# **A G E N D A**

## **Architectural Review Board**

**January 23, 2018**

728 Felder Avenue

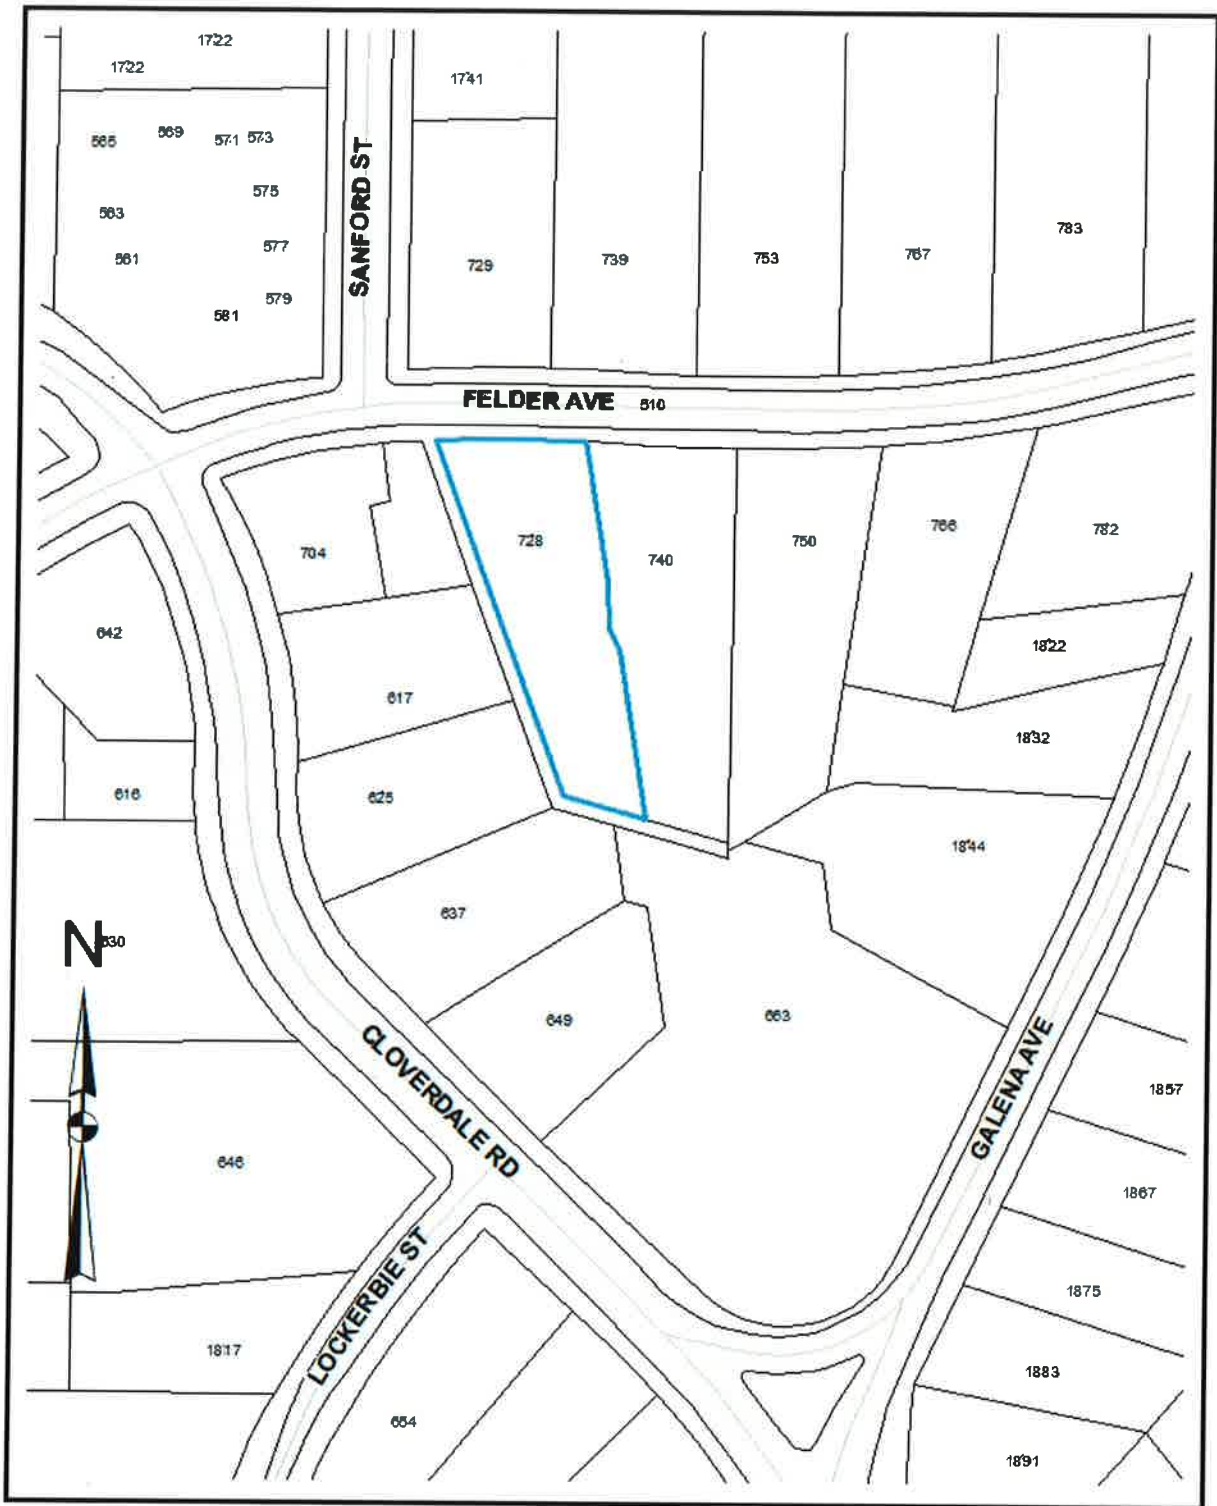
- No objection to removal of hackberry and popcorn trees subject to replacement. The catalpa at the corner is healthy with good form and structure and is a contributor to the character of the property. It’s possible to work around this tree and complete the project without damaging the tree.
